Draft Determination of Urban Development Investigation Areas within the Palmview Structure Plan Area

18 May 2018

Figure 8 DEHP Recommendation

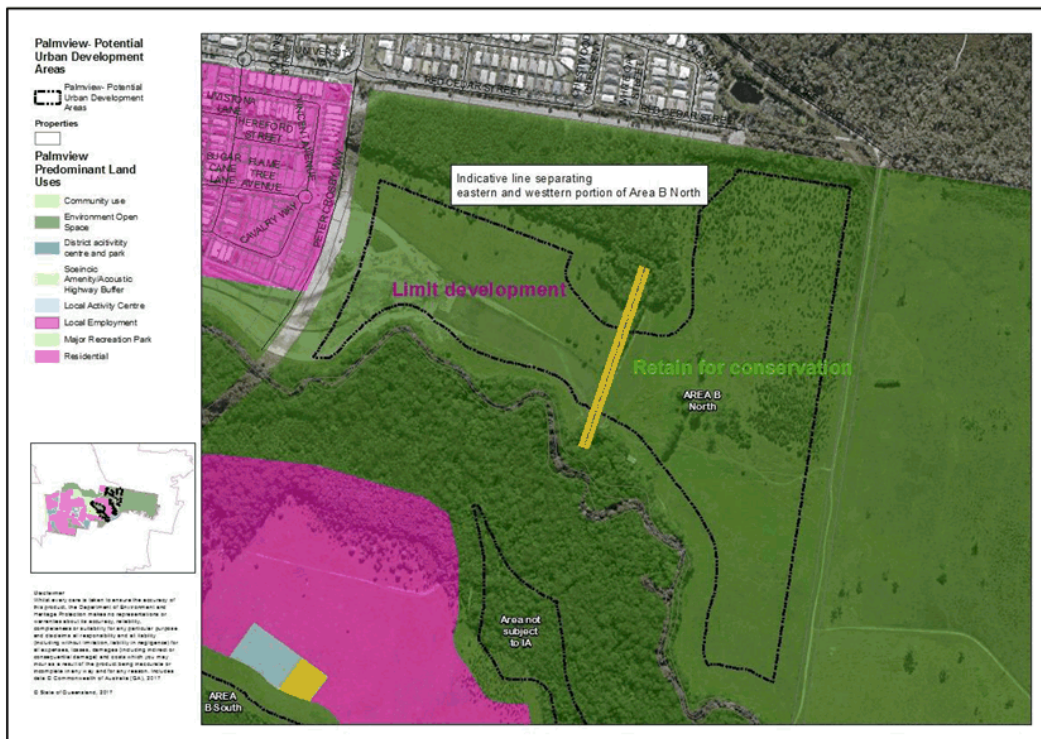
Therefore, DEHP recommends that the eastern portion of Area B North (roughly indicated in **Figure 8** below) be retained as Environmental Open Space under the Palmview Structure Plan. Rehabilitation works should occur to restore linkages and support the adjacent areas of conservation. Development in the western portion of Area B North should be limited, especially within proximity to the remnant vegetation.

Figure 10 Chenoweth Report Fig 2 Biodiversity Enhancement Strategy

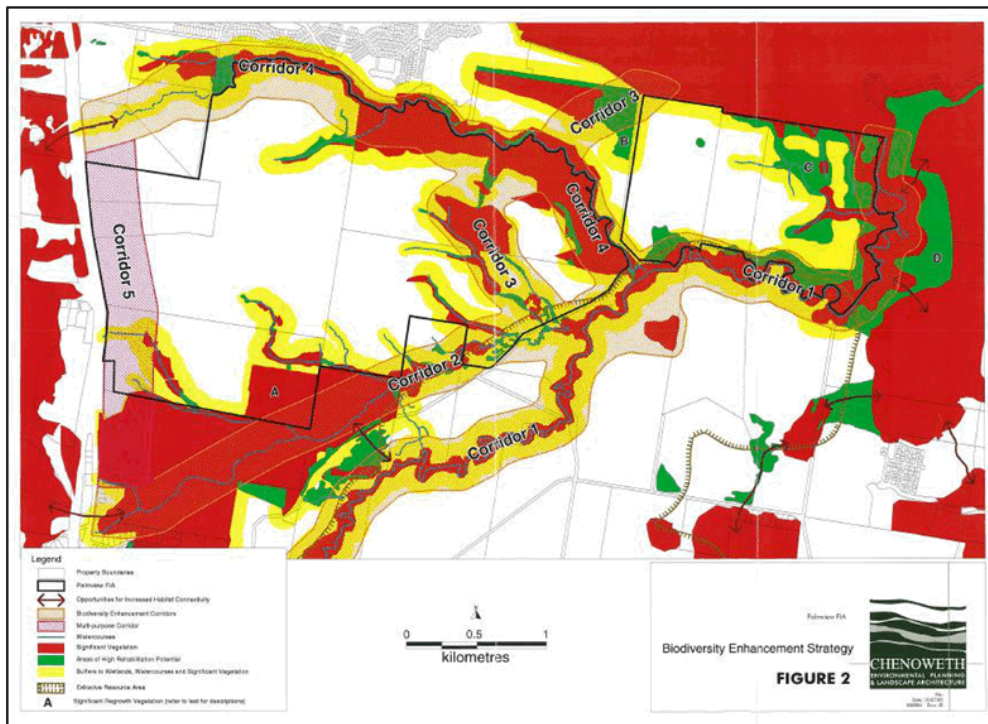
The JWA report fails to recognise Figure 2 of the Chenoweth 2005 report (refer to **Figure 10**) which identifies Biodiversity Enhancement Corridors at a sub-regional scale. Figure 2 of the Chenoweth 2005 report identifies two Biodiversity Enhancement Corridors relevant to Area B North. Corridor 4 which runs the length of Sippy Creek connecting to the Mooloolah River, and Corridor 3, which connects Sippy Creek (Corridor 4) with the Mooloolah River National Park, in doing so providing ecological connectivity to the patch of remnant vegetation in the north-western portion of Area B North which the JWA report considers representing an Ecologically Important Area, as does Council.

It is recommended that Investigation Area B North be retained to deliver habitat connectivity and wildlife movement (Refer to **Figure 10** Corridor 3 - Figure 2, Chenoweth 2005) and maintain flood storage for the Mooloolah River flood plain.

Figure 11 1%AEP Flood Level (Current Climate)

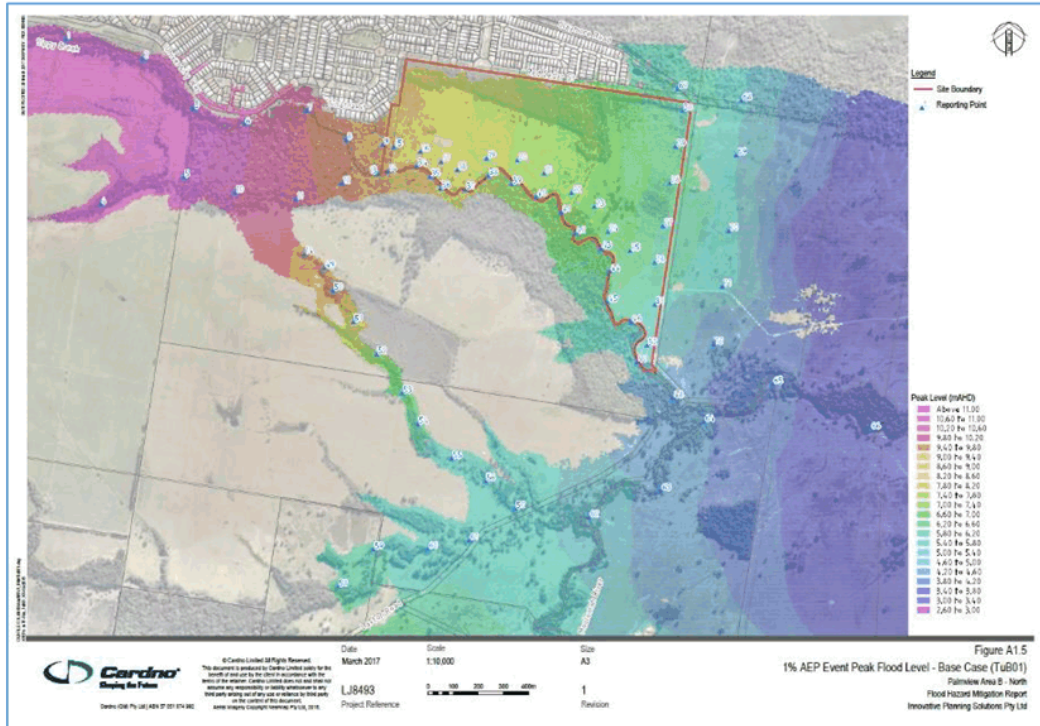
The land in Figure A1.5 of the Cardno report (**Figure 11** below) shows the 1% AEP Flood Event peak depth in a base case scenario. It indicates the entire investigation area is flood prone in an undeveloped condition. The Cardno report does not provide flood mapping for

the Defined Flood Event (1% AEP 2100 Climate) but does provide 1% AEP current climate flood mapping, which shows the site as flood prone, in the lesser flood condition. Therefore, the investigation area does not comply with the requirements of the Special Condition in the IA 2.2(b)(i), where only land in the urban investigation area that is not inundated by the defined flood event (without any modification) is suitable for urban development.

Figure 12 Engineered Solution proposed

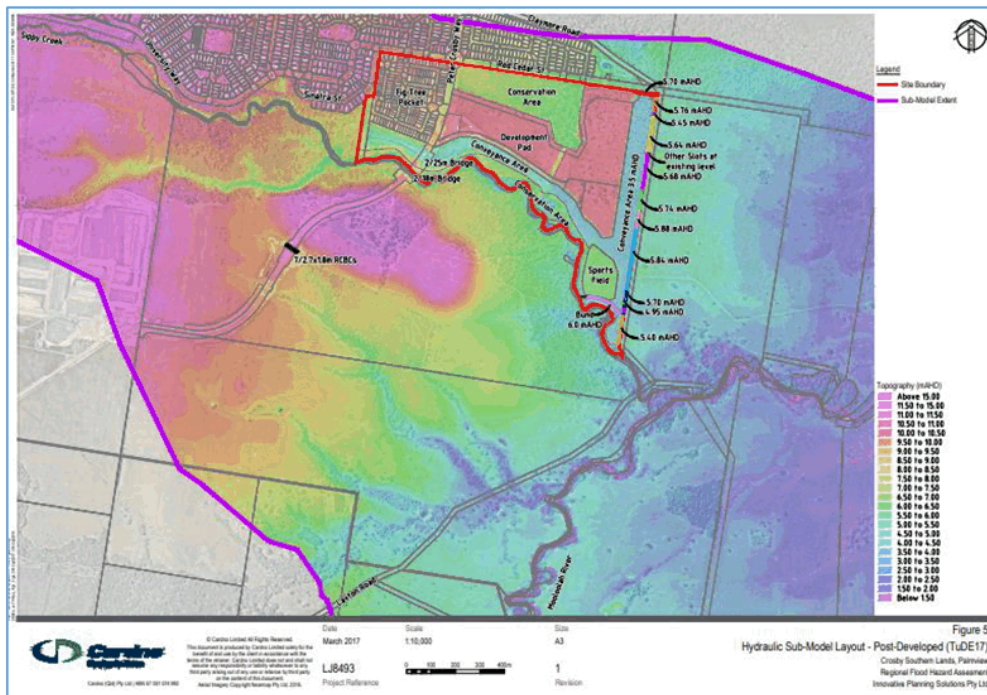
This detention area appears to create an increased depth of approximately 779mm (Figure 5 and E5 of the Cardno report), although little detail of the constructed channel and bund is provided, nor how flood waters are to exit the detention area to Sippy Creek (5.888m AHD in base case scenario at Reporting Point 45), which appears to have an AHD height greater than the conveyance channel (3.5m AHD).

Figure 13 Impact of the Area B North in the 1% AEP Flood Event

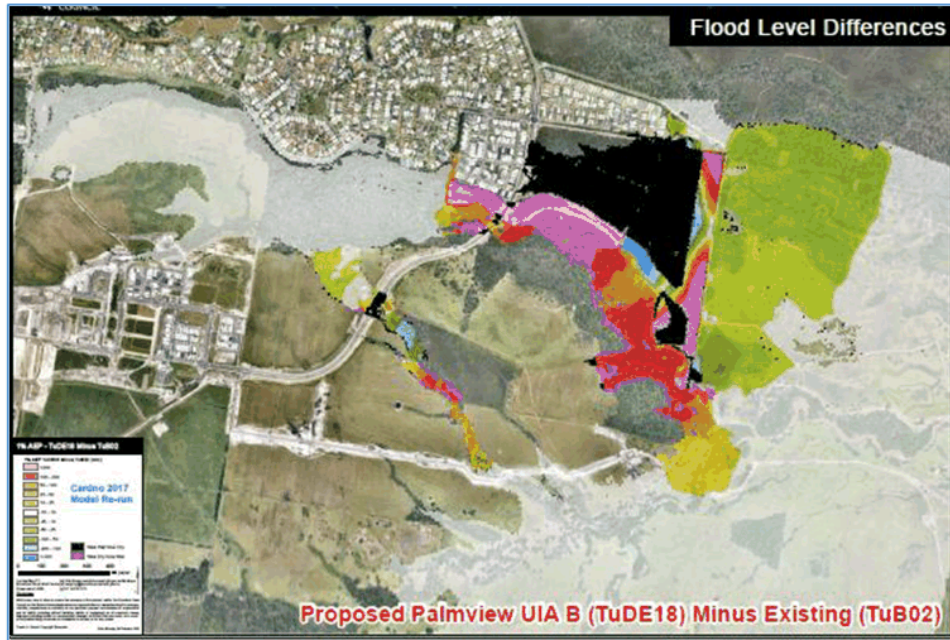
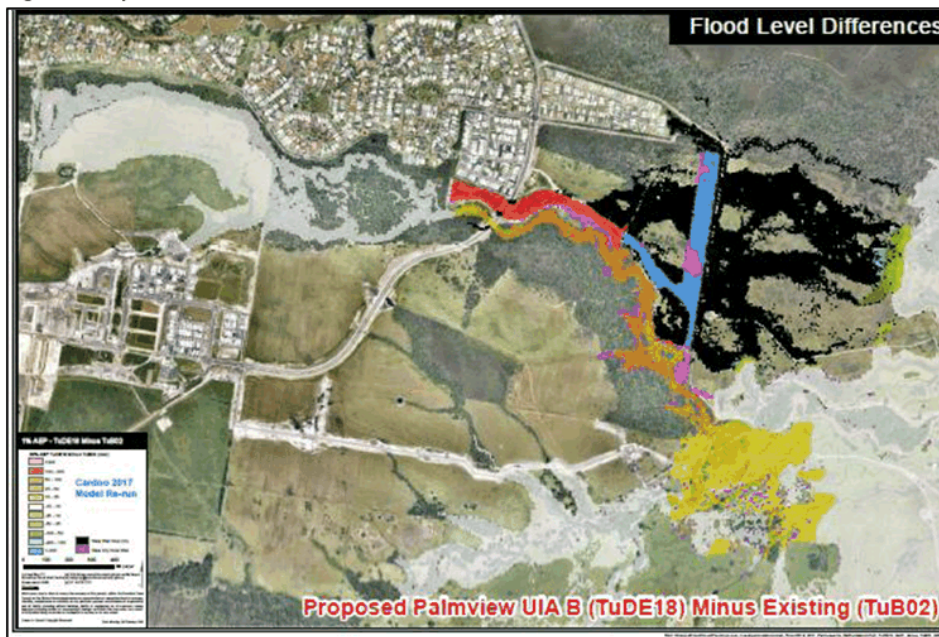
Figure 13 and **Figure 14** demonstrate that incorporating the proposed Area B North development results in increases along the Flame Tree channel and Sippy Creek for both the 1% and 39% AEP flood events. These impacts extend from the western end of Flame Tree Pocket to the confluence with the Mooloolah River.

Figure 14 demonstrates changes in peak flood levels for a small frequent flood event (39% AEP). It is evident that the channel on the eastern side of the proposed development, which provides initial conveyance and then flood storage later in an event, significantly changes the way water will flow across the site and onto adjacent Lower Mooloolah River Environmental Reserve land. The proposed development results in a material adverse impact as it represents a substantial diversion of the natural flow paths, significantly altering the hydrologic regime of the Environmental Reserve. During extended dry periods, the Environmental Reserve may not receive any flow from Sippy Creek for a number of years with this development proposal (only flows from local rainfall).

Figure 15 JWA Report Conceptual Corridor Linkages

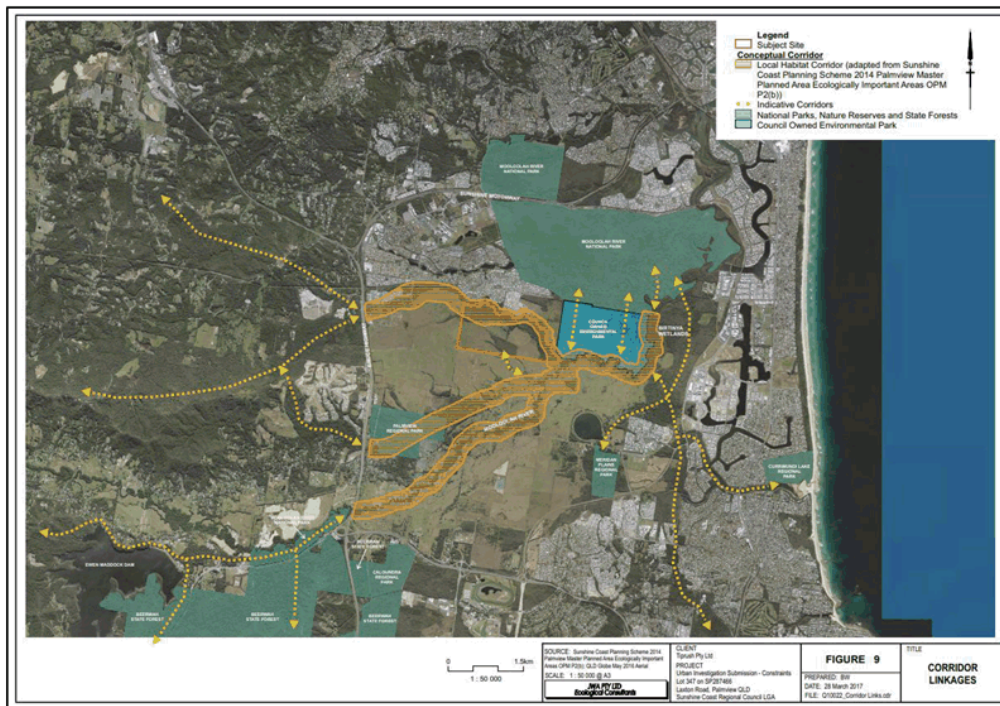
The JWA report corridor assessment (p9) references conceptual corridors shown in **Figure 15** that will provide suitable movement opportunities for a range of wildlife. **Figure 15** identifies Local Habitat Corridors that align with Sippy Creek, Un-named Creek, and Mooloolah River.

Figure 15 further identifies a number of indicative corridors including two that traverse the Lower Mooloolah River Environmental Reserve purchased by Council for environmental purposes, and a short Indicative Corridor connecting the 10ha parcel of heath and un-named Creek to the south.

The JWA report fails to recognise Figure 2 of the Chenoweth 2005 report (refer **Figure 10**) which identifies Biodiversity Enhancement Corridors at a sub-regional scale. Figure 2 of the Chenoweth 2005 report (refer **Figure 10**) identifies three Biodiversity Enhancement Corridors relevant to Investigation Area B South. Corridor 4 which runs the length of Sippy Creek connecting to the Mooloolah River, Corridor 3 [south], which connects the approx. 10ha of heath vegetation south via Area C to un-named Creek, and Corridor 2 which aligns with un-named Creek connecting with the Mooloolah River.

Figure 16 JWA Proposed Heathland Translocation Site

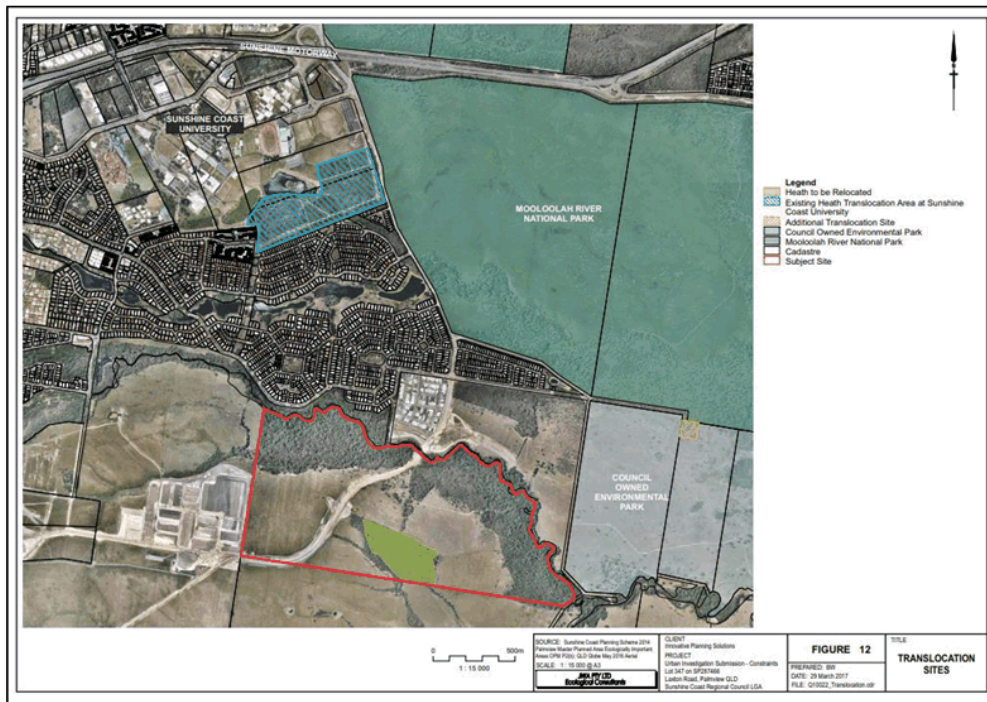
Translocation of habitats including heath is inherently high risk and susceptible to high rates of failure. The Lower Mooloolah River Environmental Reserve was purchased by Council to

Figure 17 1% AEP Climate Change Event Peak Flood Depth

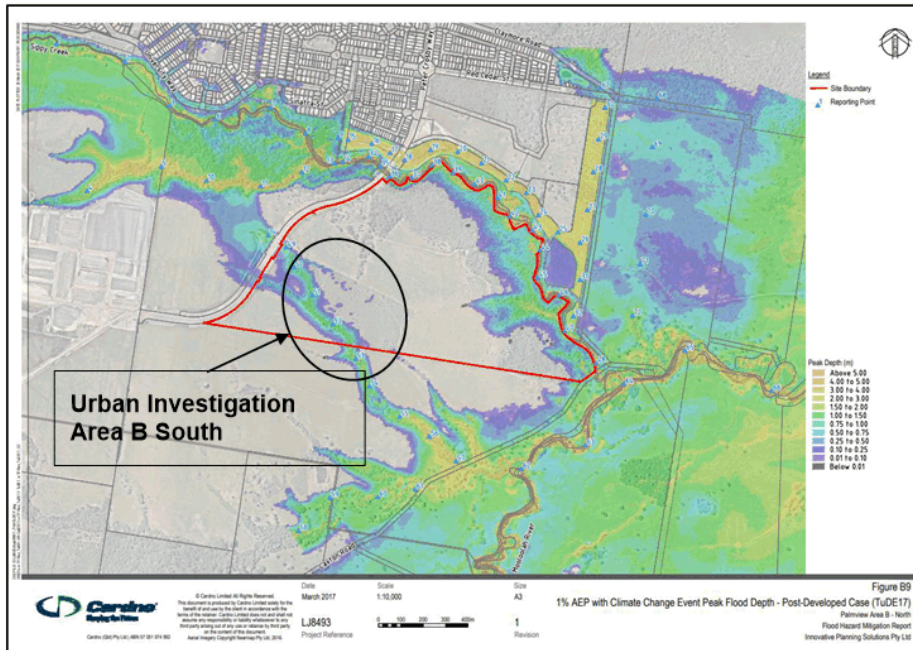
Figure A9 of the Cardo report shows the peak level compared with the topography (m AHD) while Figure B9 of the report (refer to **Figure 17** below) shows the peak depth of water in the flood event. **Figure 17** shows a significant area of the Urban Investigation Area of Area B South is inundated by floodwaters, up to two metres depth. This waterway also flows through to Area C.

The Cardno report indicates that some parts of Area B South will comply with the requirements of the Palmview IA 2.2(b)(i) – ie, “not flood prone land”. That is, without any modification of the waterways that convey floodwaters, there is a portion of the urban investigation area that is not inundated by the defined flood event and therefore not precluded from for urban development on those grounds.

However, the Cardno flood report was not clear in whether it was presenting a pre-development case for Area B South. The report references Post-Developed a TuDE17 scenario, and the flood mapping in the appendices of this report also reference Post-Developed Case (TuDE17) in the context of Palmview Area B North. Further information was requested to clarify this.

Figure 19 - 1% AEP Existing Flood Depth (2100 Climate Change)

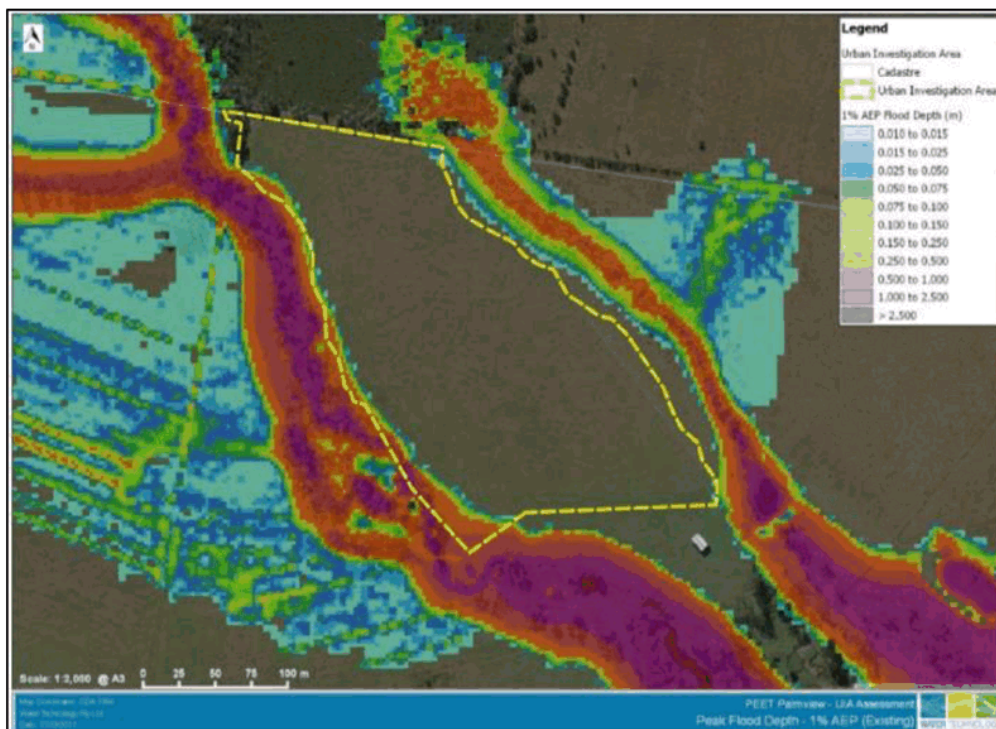
In summary, Figure 3-1 of the Water Technology report (refer **Figure 19**) indicates the south-western corner of the Urban Development Investigation Area is inundated, by up to 750mm. There is some minor flooding along the western edge of the Urban Development Investigation Area. Similarly, there is minor flooding on the north-east corner.

Outside of these areas, the assessment indicates that much of the Investigation Area C can comply with the requirements of the Special Condition 2.2(b)(i) of the Palmview IA, that is, without any modification of the waterways that convey floodwaters for the majority of the urban investigation area is land suitable for urban development because the defined flood event does not inundate it.

Figure 20 Proposed Community Facilities Precinct

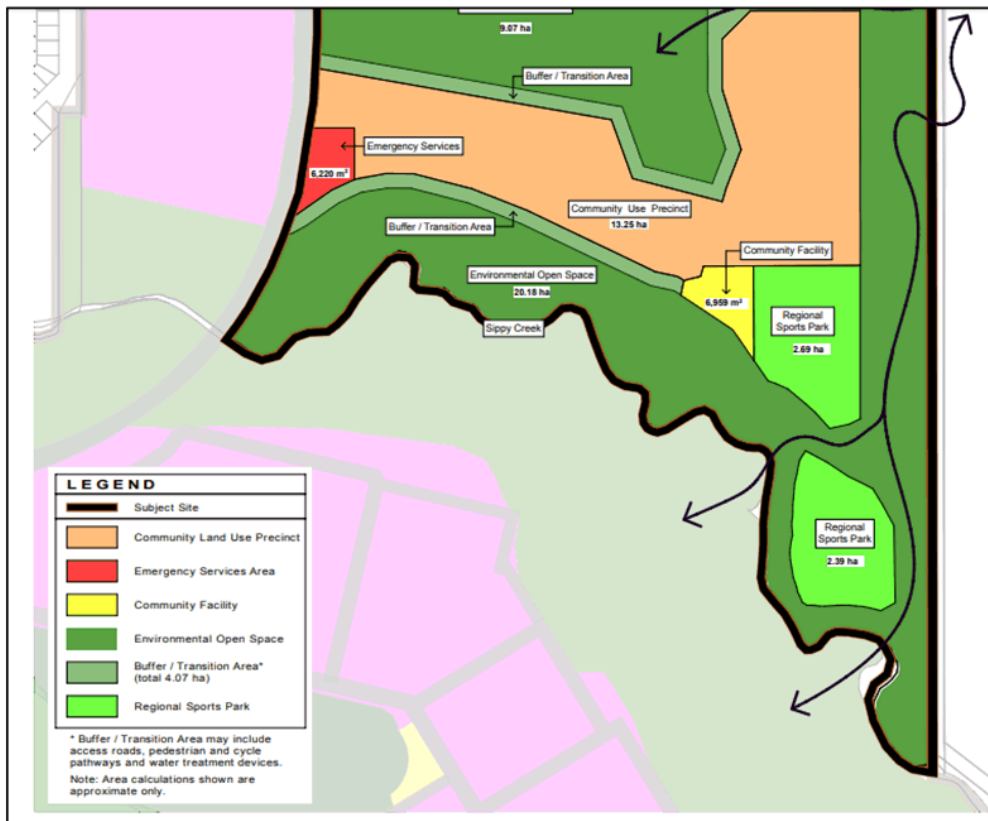
The landowner proposal (refer **Figure 20**) is to develop Area B North to incorporate:

In conclusion, standalone buildings in isolated areas are not supported for general access unless the proposed use has a synergy or specific purpose such as an environmental education centre or use related to the nearby natural areas. In addition, network planning indicates there is no further land required for community facilities within Sippy Downs or Palmview.
